*TOLEDO CITY
PLAN COMMISSION
REPORT*

November 3, 2016

**TOLEDO-LUCAS COUNTY PLAN COMMISSIONS
APPLICATION DEADLINE, AGENDA, STAFF REPORT AND HEARING
SCHEDULE - 2017**

ADDITION #1 LANDSCAPING PLAN

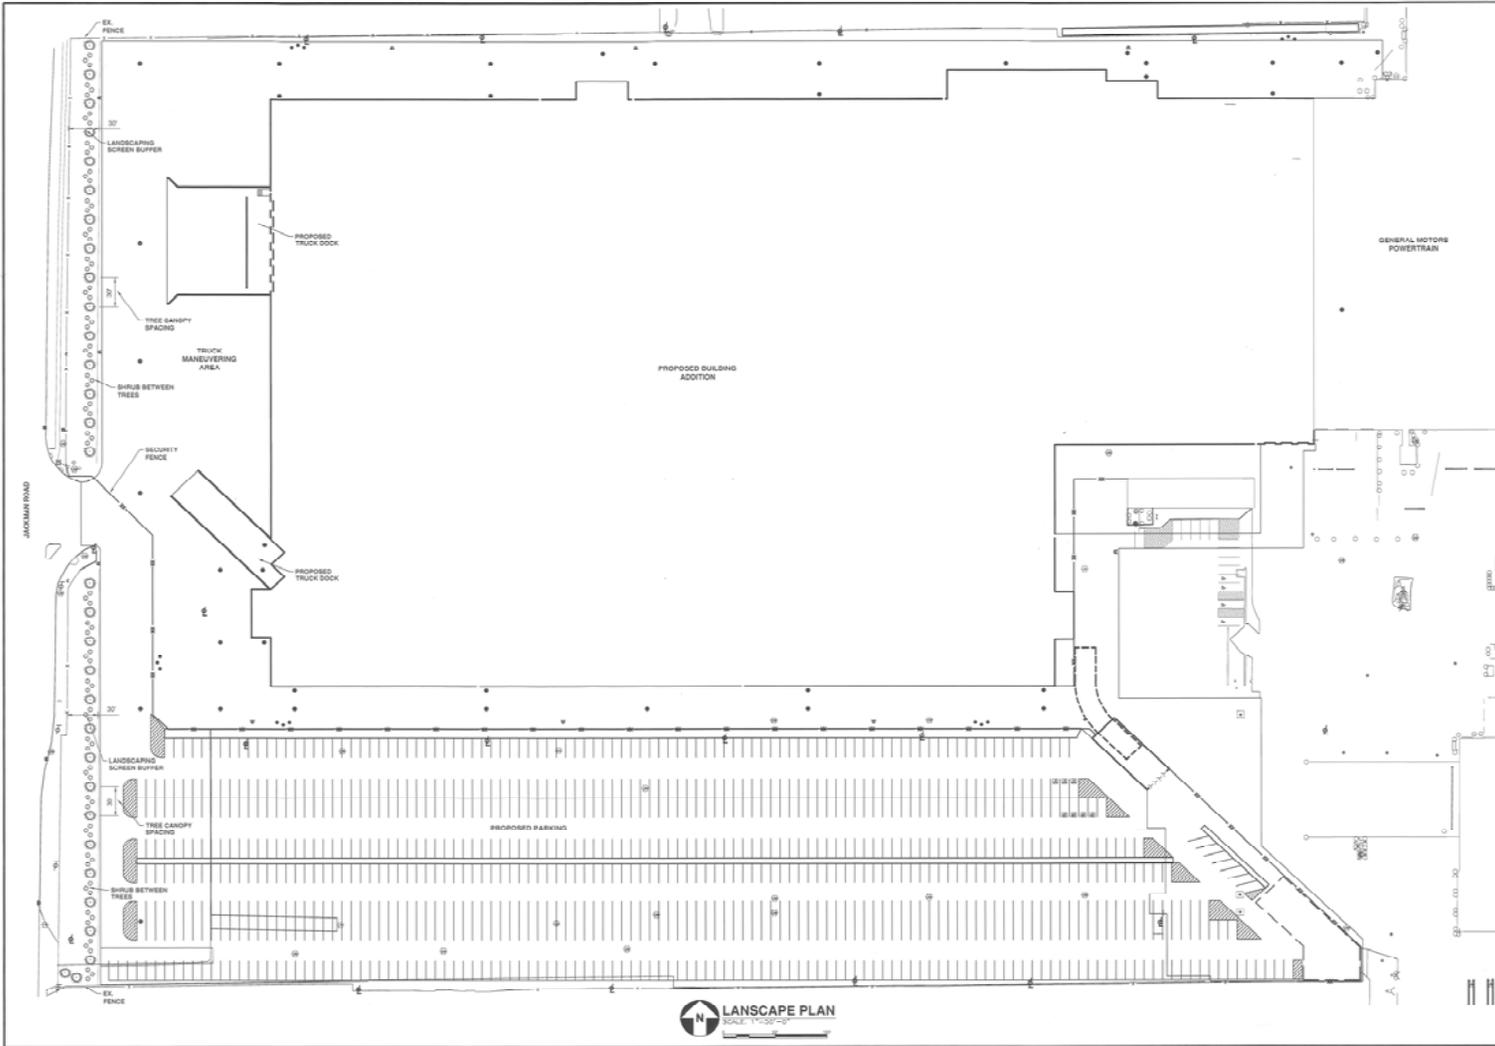
- a. A thirty-foot (30') greenbelt is required along the Jackman Road frontage in front of the new addition, and shall one tree per every 30 feet of frontage; **acceptable as depicted on landscaping plan**.
